Number	A.1.
Section	General Information
Sheet	1 (of 1)
Date	January, 1960

PRELIMINARY INFORMATION

(Mark 2 Models)

SERVICE BULLETIN NO. 187

PANHARD ROD OUTER BRACKET.

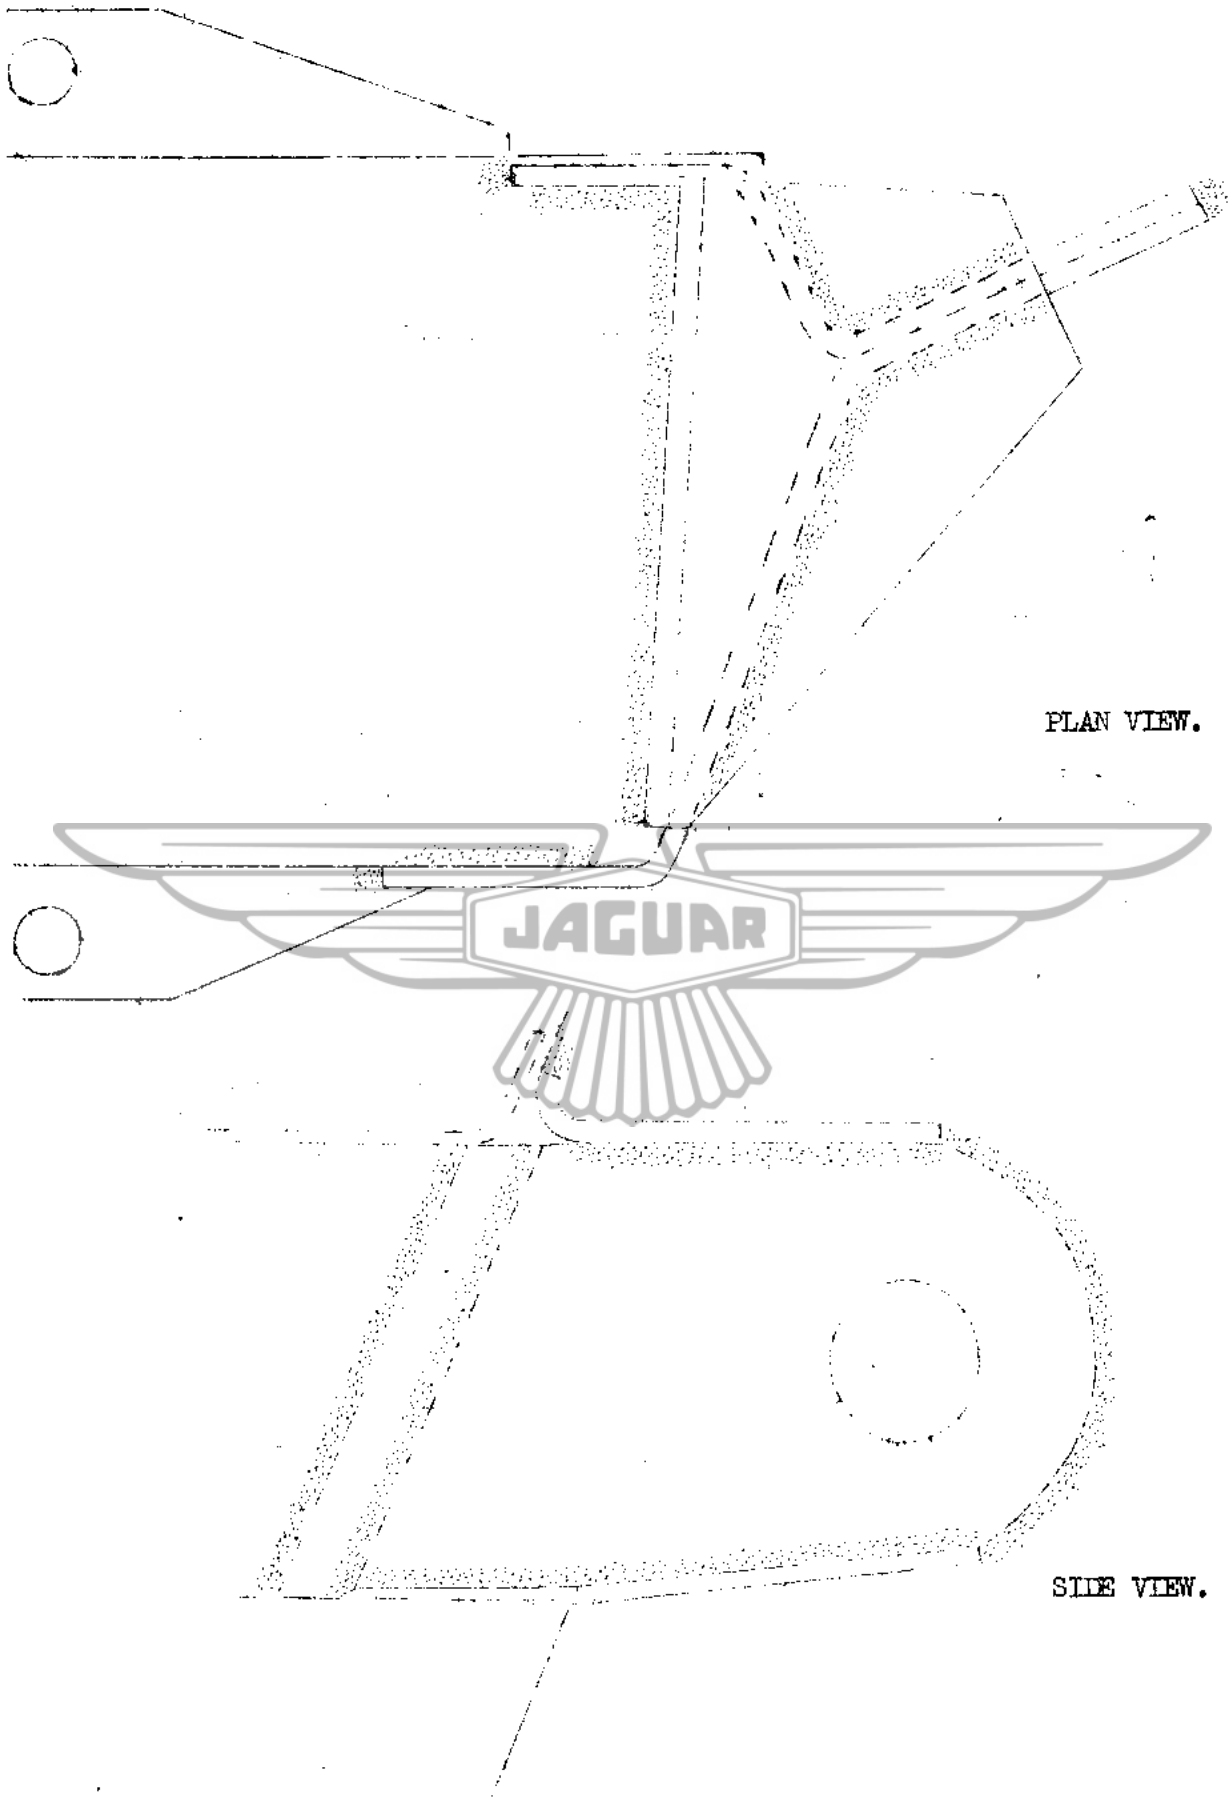
In the case of your having an actual breakage reported please take the following action:-

- 
1. Disconnect the panhard rod from the rear axle bracket.
 2. Remove the broken piece of bracket from the panhard rod and if the two pieces of plate are not spot welded together, weld around the two rounded edges ensuring that the two holes are in line.
 3. Mate up the two parts of the broken bracket at the point of fracture and weld together.
 4. Carry out the necessary welding to ensure that the bracket is welded at all the positions indicated in the following sketches.
 5. Repaint the bracket and refit the panhard rod.

Sketch 1
Side view.

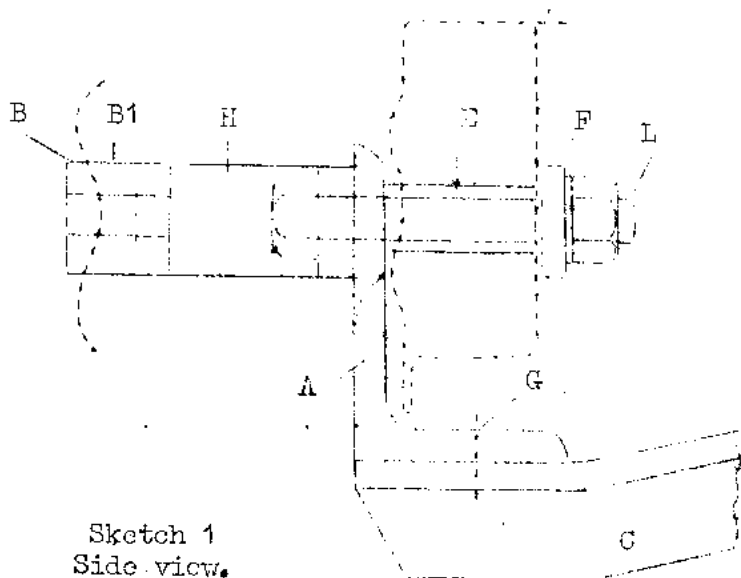
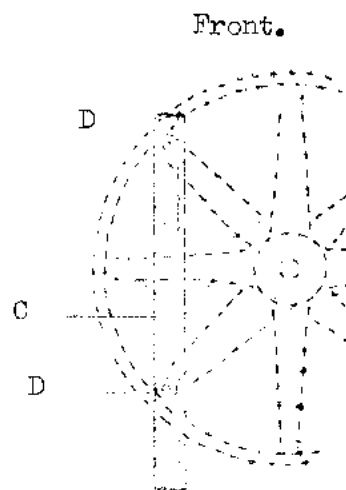
Remove spare wheel. On the horizontal centre line of bumper drill, say, 3/8" hole 1.3/4" each side of centre line (marked vertically from boot lock), i.e. at standard 3 1/2" centre for coupling.

Pilot or mark through these holes on to rear body skirt, taking care to project horizontally and to maintain the 3 1/2" centres.

Detach bumper by undoing, on the inner mounting, the 1/2" bolts screwed into rubber centre and, on the outer mountings, the smaller bolts holding the rubber blocks to the body, and spring one end of bumper away first. (Take care that the other bumper end does not cut the paint when detaching or when remounting). Open up holes in bumper to 21/32".

At the two points marked (at 3 1/2" centres) on the body skirt drill 21/32" holes right through both panels and then file out holes in outer or rearmost panel to close fit on Bushes (E) 7/8" diameter. Assemble Cross Bar (A), Yoke (H) and Plate (F) with Bolts (L) and Bushes (E) as sketch 1 - but insert Bolt (G) first.

Attach Bracing Bar (C) loosely to Cross Bar (A) with Bolts (G) and, after positioning, as Sketch 2, drill two 13/32" holes up through the centres of the ribs in the spare wheel container and attach with Bolts (D). Washers should be used between Bracing Bar (C) and Cross Bar (A), or between Bracing Bar (C) and spare wheel floor, if required, to ensure that this floor is not stressed when the bolts are tightened up.

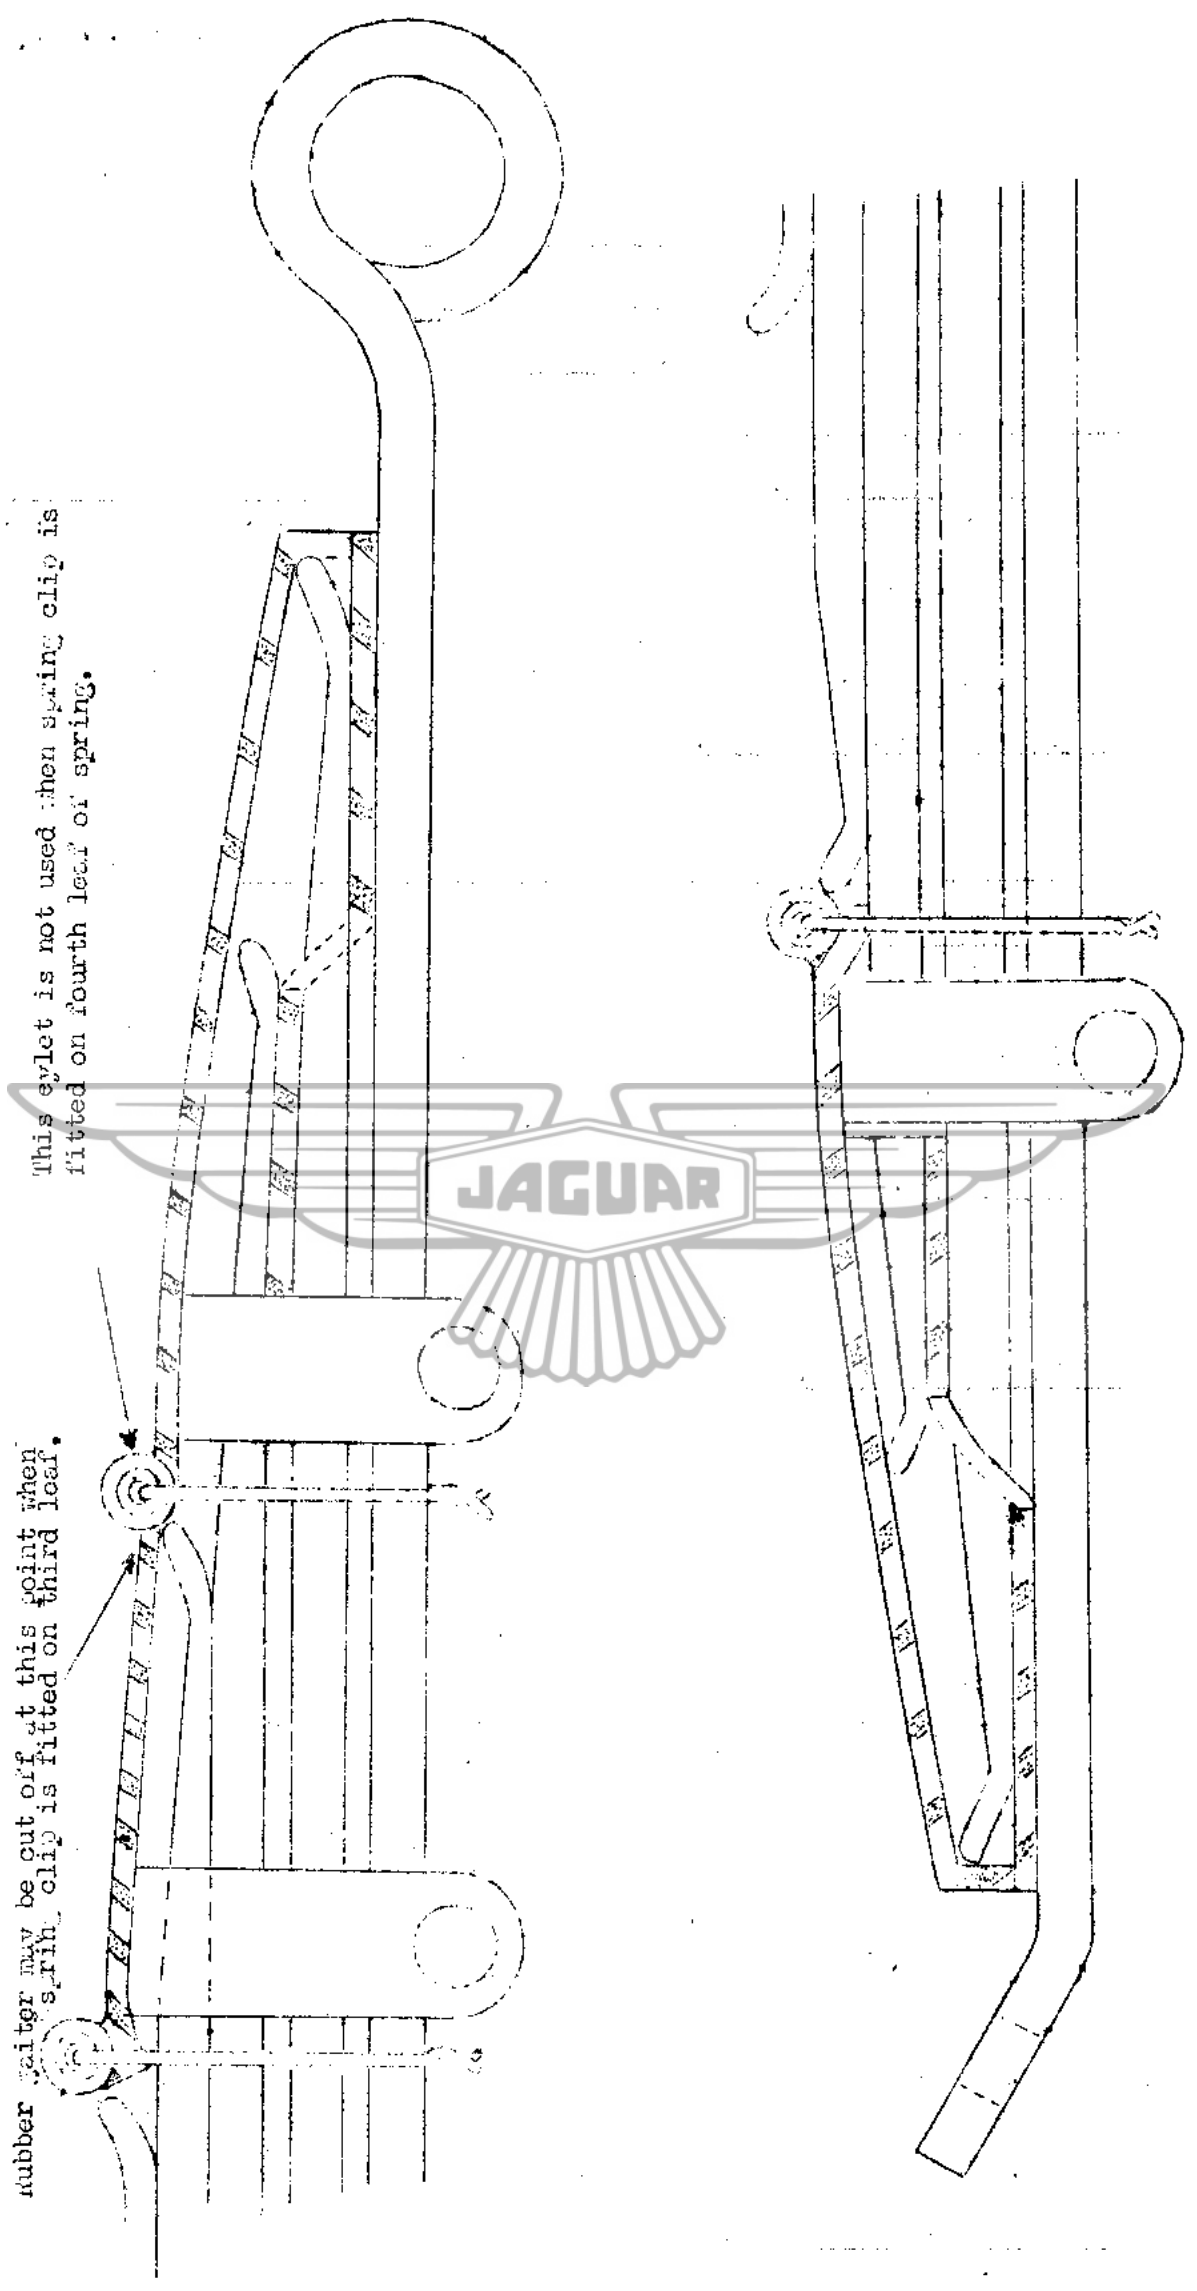
If complaints of knocking or creaking from the rear springs are received gaiters should be fitted in accordance with the following instructions. This modification applies only to springs NOT fitted with synthetic rubber buttons. (see above).

C12521 Rubber gaiter-short (Front end of spring)	2 off
C12518 Rubber gaiter-long (Rear end of spring)	2 off
C12668 Spring clip bolts	4 off

1. Remove rear springs as described in Service Bulletin No.182.
2. File off the beened over ends of the spring clip bolts and remove the bolts and distance pieces.

STARTER MOTOR - REMOVAL

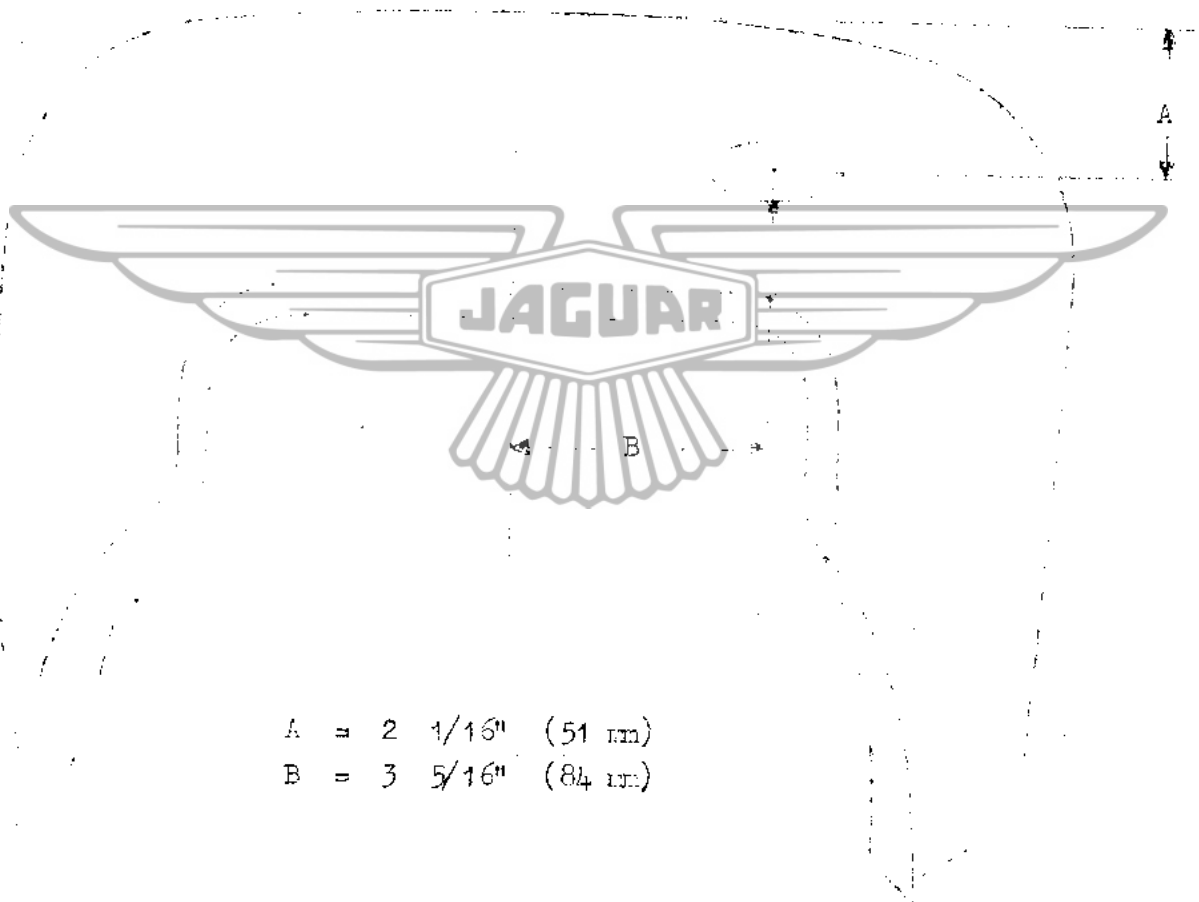
The two bolts securing the starter motor are welded to a semi-circular plate and two securing nuts are fitted adjacent to the clutch housing.

When removal of the starter is necessary on early cars without this aperture a hole can be made in gearbox cowl at the position shown in the following sketch. After making a suitably sized hole to gain access to the top securing nut, a sheet metal cover plate should be made up and secured with three self-tapping screws.

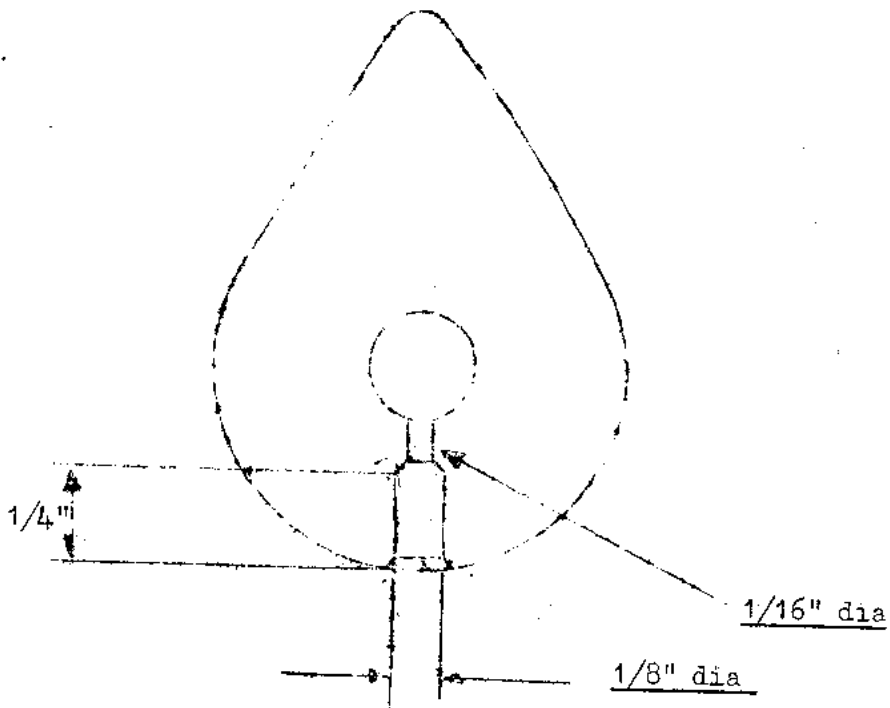
If complaints of tappet noise when starting from cold are received this modification can be carried out in service by carrying out the following procedure.

1. Support the camshaft on Vee blocks at the front and rear bearing journals and clamp down the camshaft while drilling each cam.
2. With a high speed drill make an $\frac{3}{8}$ " (3 mm) diameter hole $\frac{1}{4}$ " (6.35 mm) deep in the centre of the base of each cam and follow through with a $\frac{1}{16}$ " (1.5 mm) high speed drill until the hole breaks through into the main oilway. (see sketch). Chamfer the edge of the $\frac{3}{8}$ " hole to remove the sharp corner.
3. After drilling all the cams thoroughly wash out the oilways to remove all traces of drilling swarf.

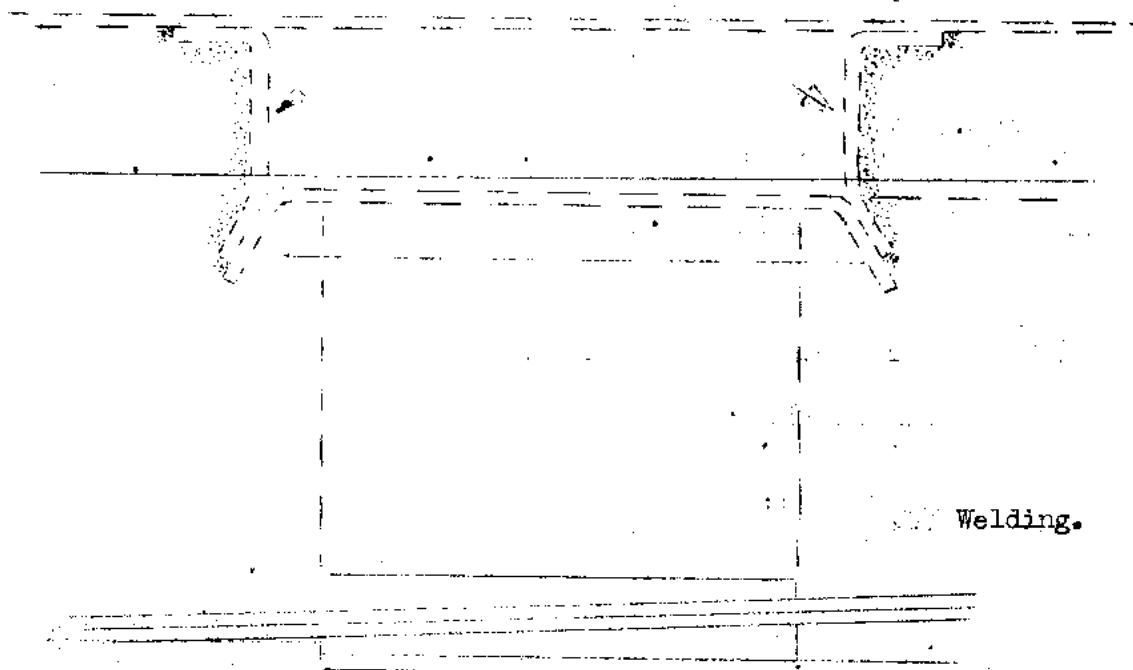
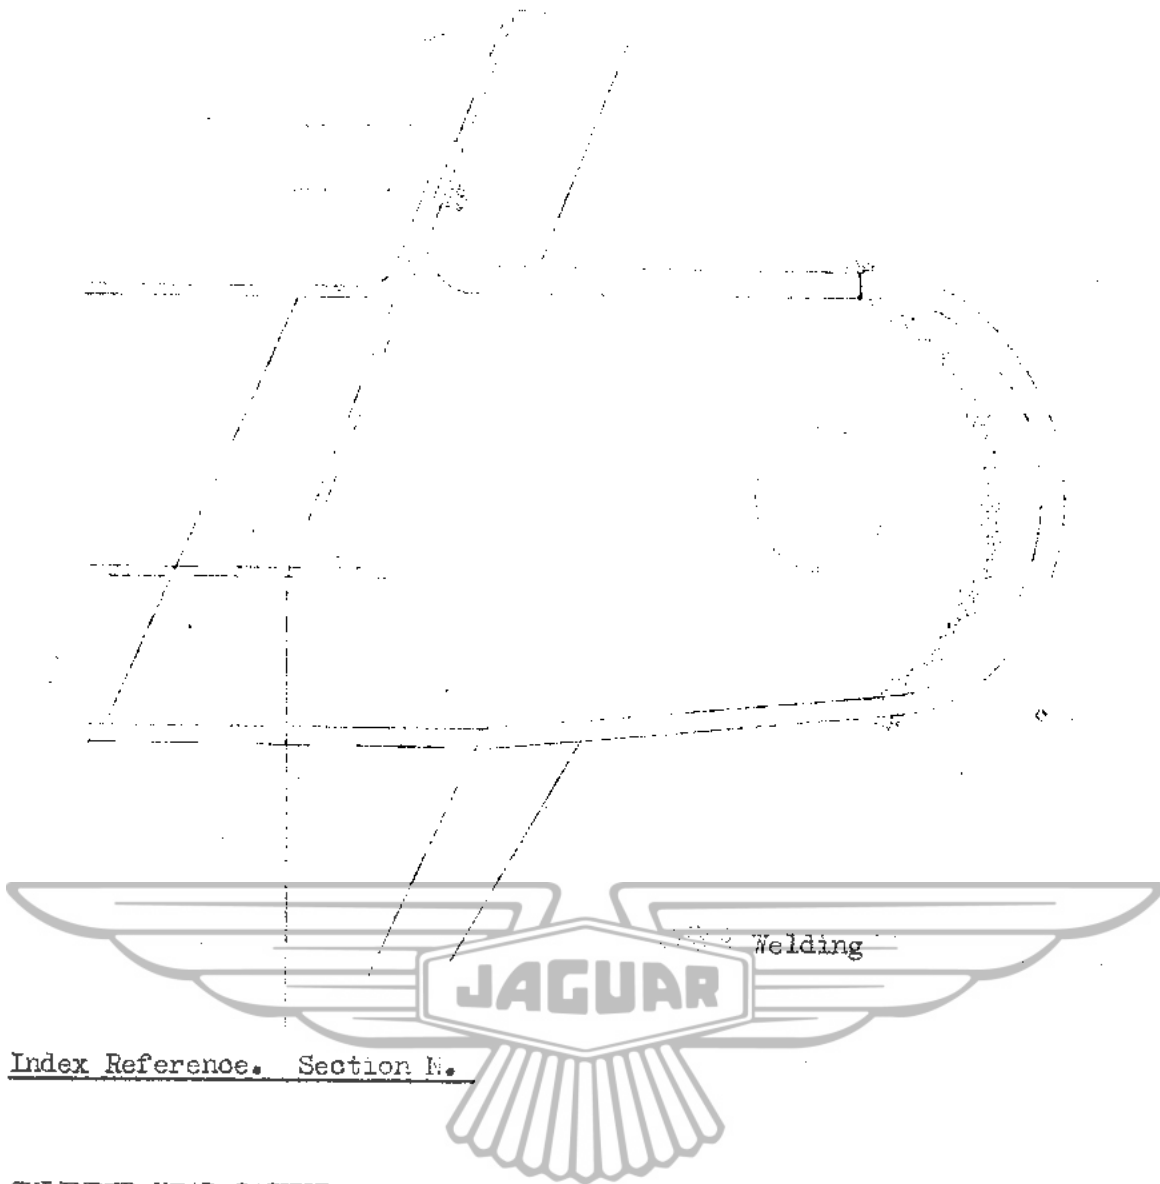
If a complaint of knock from the rear springs is received which cannot be traced to the rear springs themselves, the upper spring mounting clamps (see Fig 2 items 6 and 7 in the Integral Body/Chassis Repair Manual) should be examined for distortion. If any distortion exists this should be rectified and in addition support brackets, (Part number C.12779) should be fitted and welded between the spring mounting clamp and the spring reinforcing channel (Fig 2, item 5) as shown in the following sketch.

Note:- At the left-hand side a support bracket is fitted at both front and rear of the spring mounting clamp.

At the right-hand side, a support bracket is fitted at the front of the spring mounting clamp only.
